to the
Bidding Documents

9 April 2012

Don D. Sherrill Education Center
Lincoln Public Schools
340 N. 56th Street
Lincoln, Nebraska 68504
BCDM Project No. 4891-00

NOTICE TO BIDDERS: The Project Manual and Drawings for the above referenced project are hereby amended as follows:

4891-00	DRAWING REFERENCED:	1/A1-1	ATTACHMENT
DATE: 04/09/2012	ADDENDUM #01		ASD-01

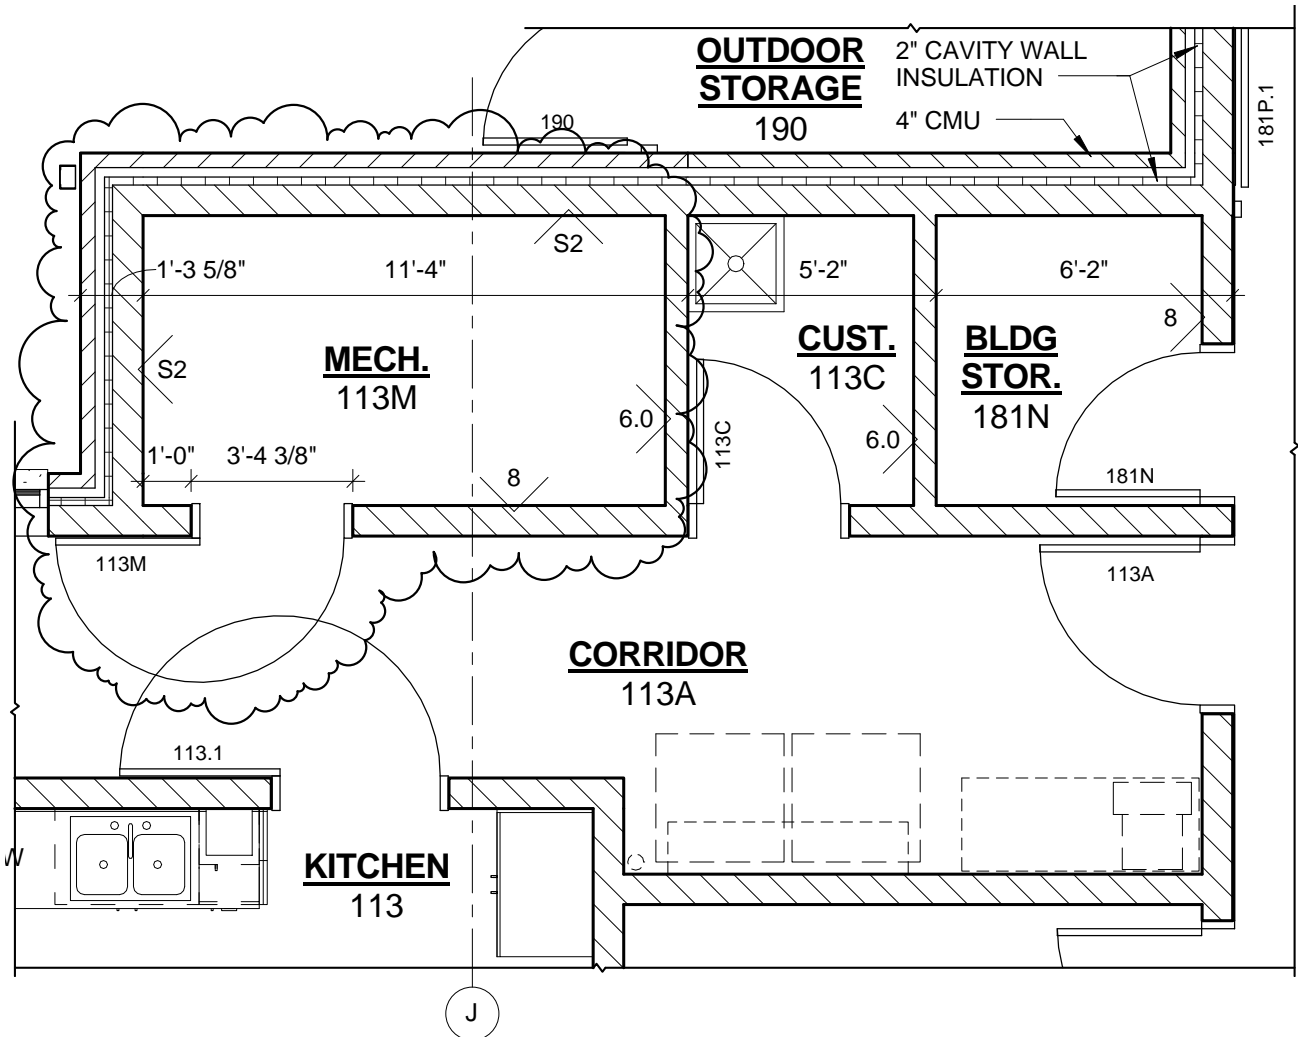
1AD1. SHEET A1-1, DETAIL 1 FIRST FLOOR PLAN

- a. Revise layout of Corridor 113A, Mechanical 113M, Custodial 113C and Building Storage 181N as shown on Attachment ASD-01 to this Addendum.

4891-00	DRAWING REFERENCED:	14/S3-1	ATTACHMENT
DATE: 04/09/2012	ADDENDUM #01		SSD-01

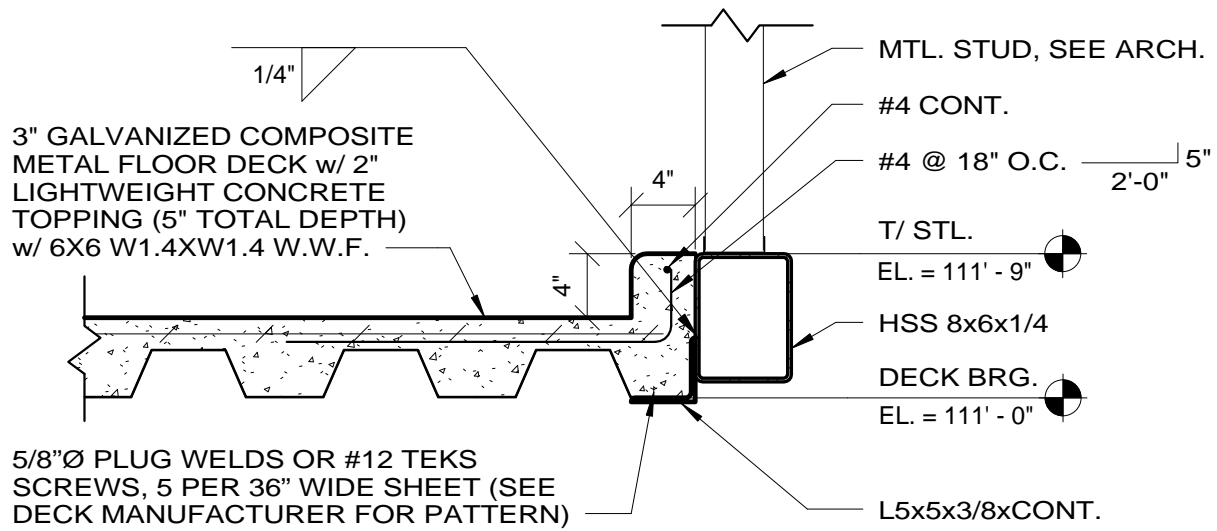
1SD1. SHEET S3-1, DETAIL 14 DECK EDGE DETAIL AT BOND BEAM

- a. Delete existing detail in its entirety and substitute the detail included as Attachment SSD-01 to this Addendum.

PROJECT NO.	DATE	DRAWING REFERENCED:	E1-1	SKETCH ES-1
20112177	04/09/12	ADDENDUM NO.:	1

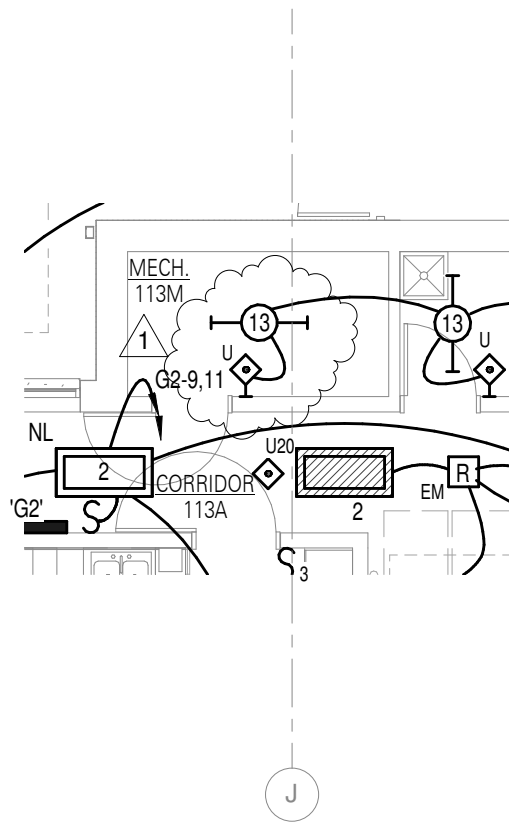
1ED1. SHEET E1-1 –FIRST FLOOR PLAN LIGHTING

- a. Revise per attached sketch sheet ES-1.

PROJECT NUMBER 20112177	DATE 04/09/12	DRAWING REFERENCED: ADDENDUM NO.:	E2-1 1	SKETCH ES-2
----------------------------	------------------	--------------------------------------	-----------	----------------

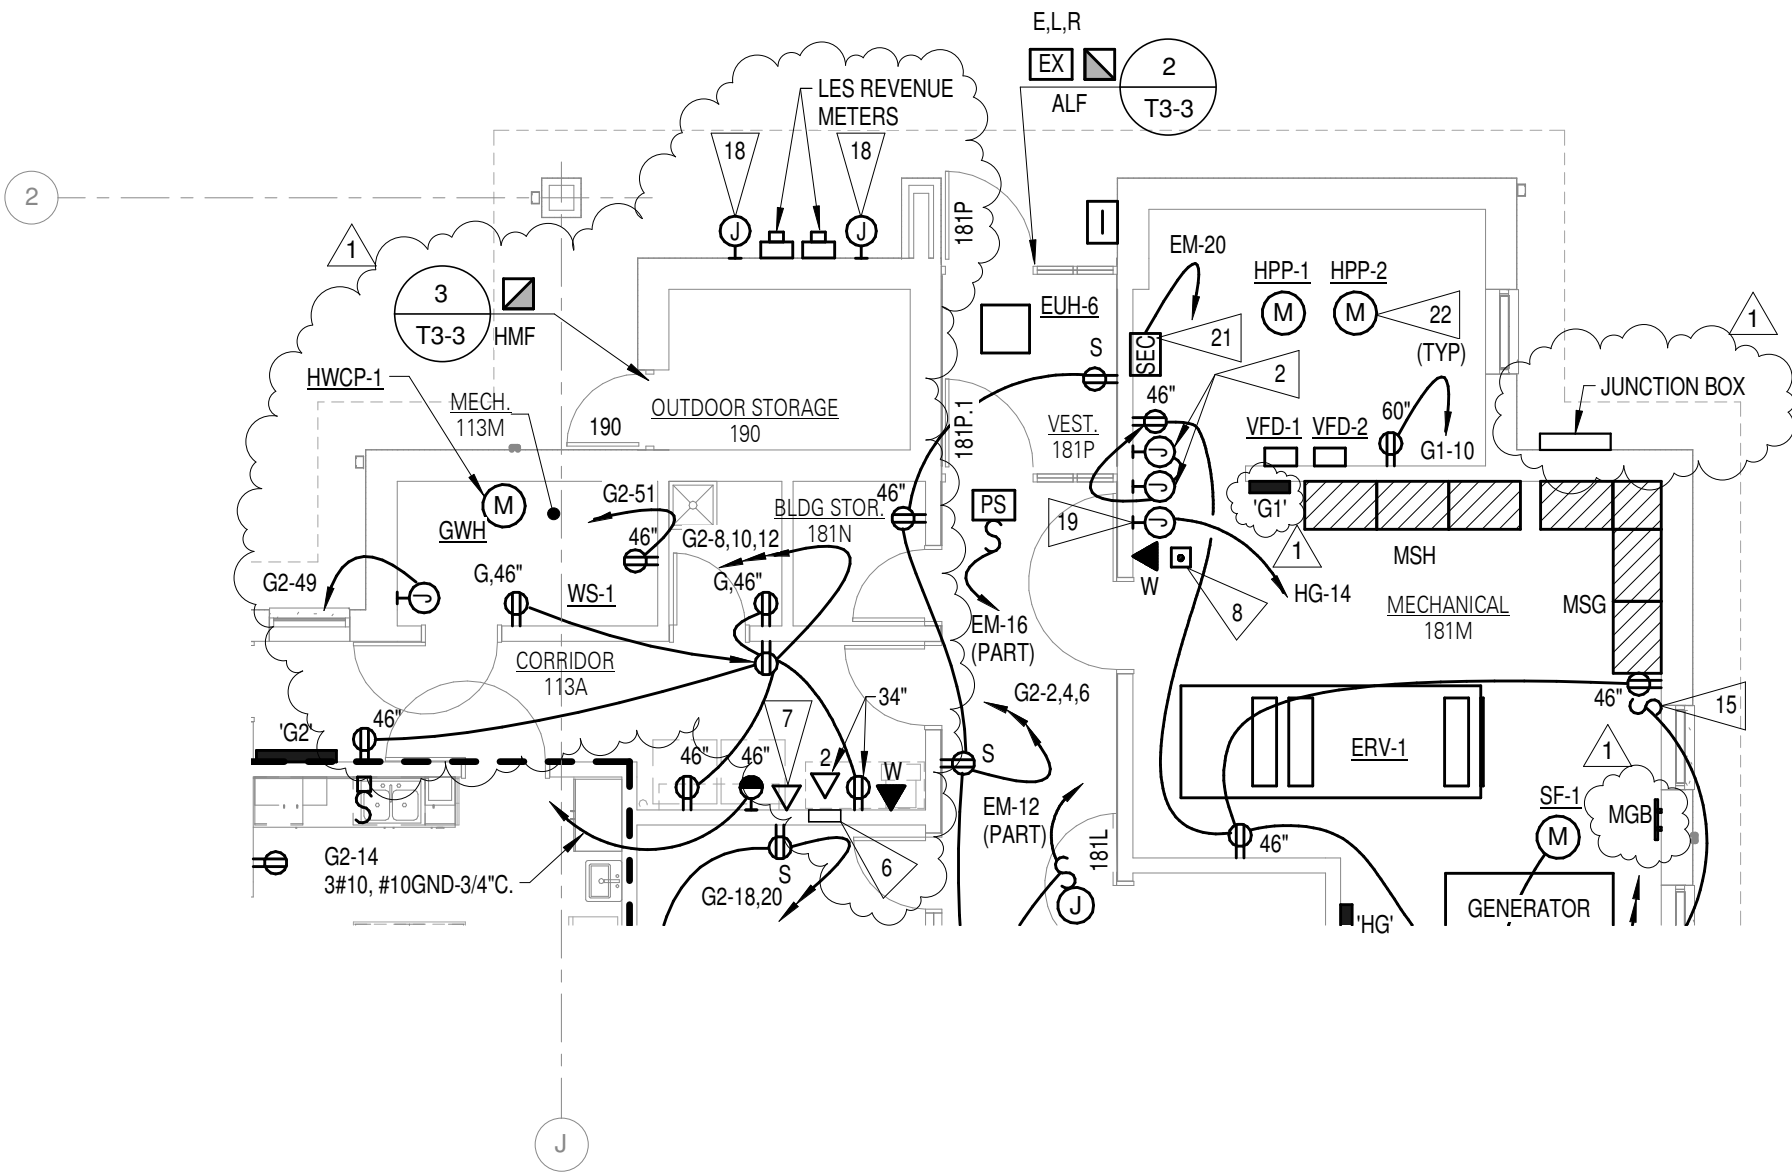
1ED2. SHEET E2-1 – FIRST FLOOR PLAN - POWER

- a. Revise per attached sketch sheet ES-2.

PROJECT NO. 20112177	DATE 04/09/12	DRAWING REFERENCED: E3-1	SKETCH ES-3
		ADDENDUM NO.: 1

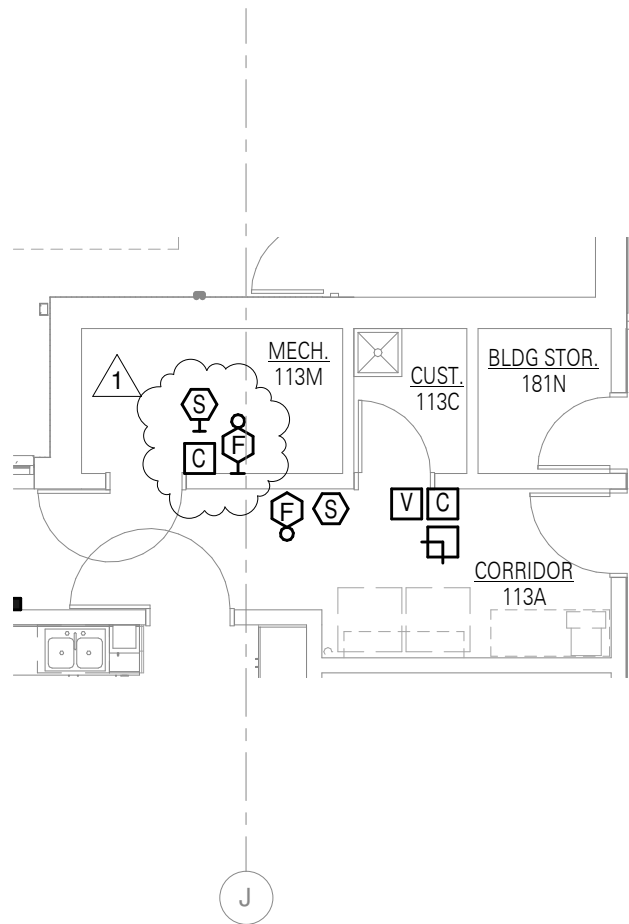
1ED3. SHEET E3-1 – FIRST FLOOR PLAN – SPECIAL SYSTEMS

- a. Revise per attached sketch sheet ES-3.

SKETCH
ES-4

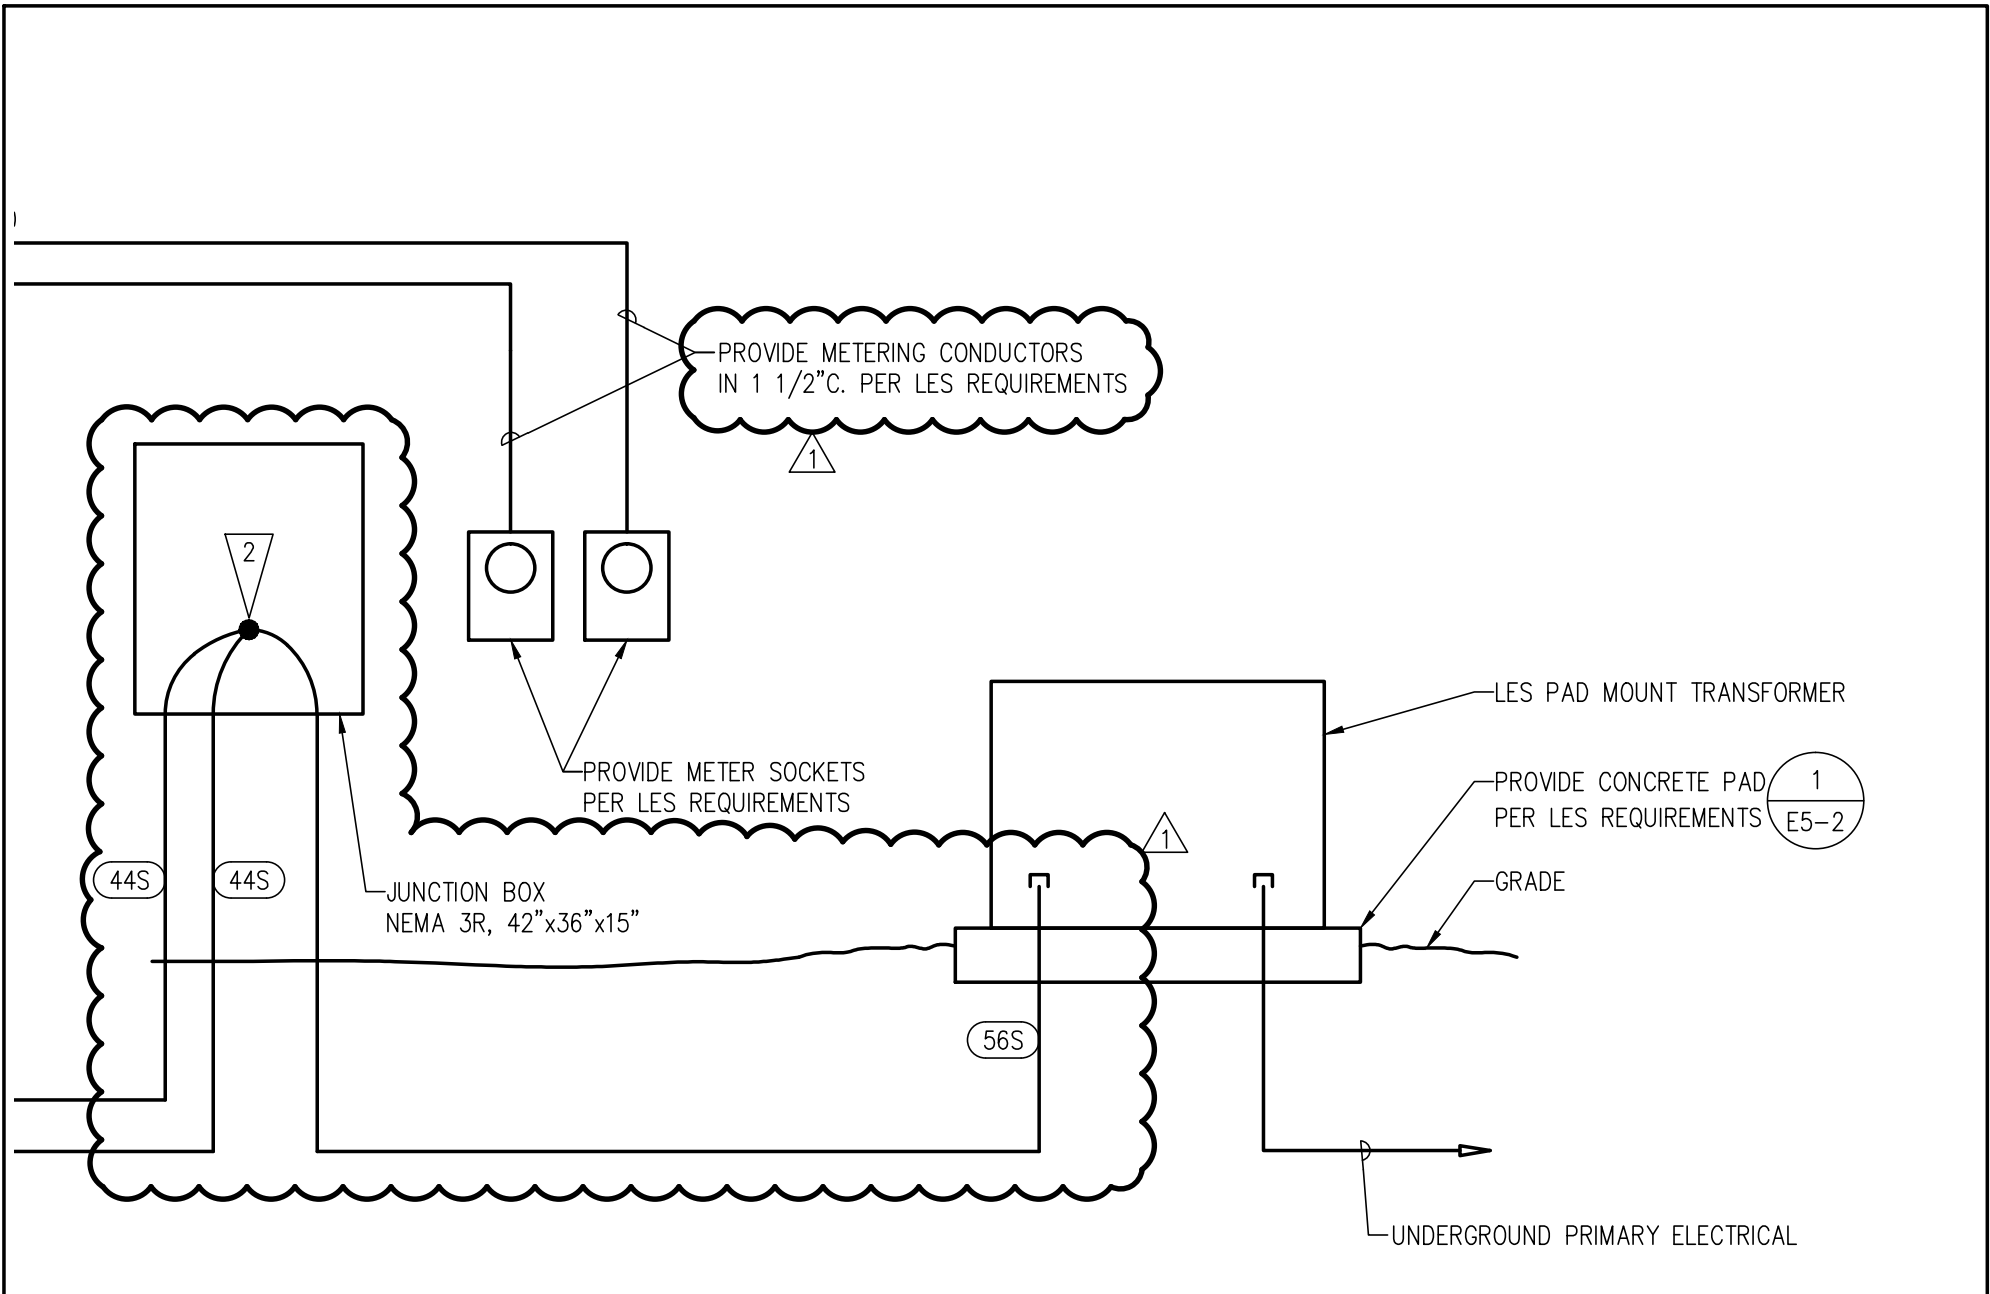
1ED4. SHEET E4-1 – POWER RISER DIAGRAM

- a. Switchboard 'MSH'. Change AIC rating to 42,000.
- b. Switchboard 'MSG'. Change AIC rating to 42,000.
- c. Power Riser Diagram. Revise per attached sketch sheet ES-4.
- d. Feeder Schedule. Revise per attached sketch sheet ES-5.
- e. Flag Notes. Revise per attached sketch sheet ES-5.
